NICHOLAS GARAGE AND STORAGE SHED UNHEATED

Date: 08/13/2021

Building TB-21-934

NICHOLAS CONST DWGS 7-30-21 ESTAMP.pdf Markup Summary

Level, Roof: Drop Beam

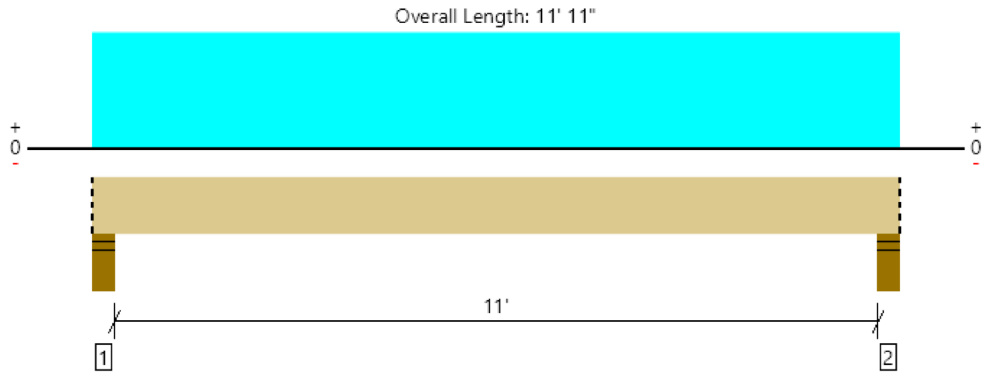
b. The Building Plans must include a full structural design of all vertical and lateral loads including a roof structure that meets our local Ground Snow Load values included in the calculations and design of the footings/foundation. ~~The snow load (45 psf) appears to be in error~~. See attached Forte calculation Failures.

Level			
Member Name	**Results**	**Current Solution**	**Comments**
Roof: Joist	Passed	1 piece(s) 2 x 12 DF No.2 @ 12" OC	
Roof: Drop Beam	Failed	1 piece(s) 6 x 12 DF No.2	
Roof: Drop Beam	Failed	1 piece(s) 6 x 14 HF No.1
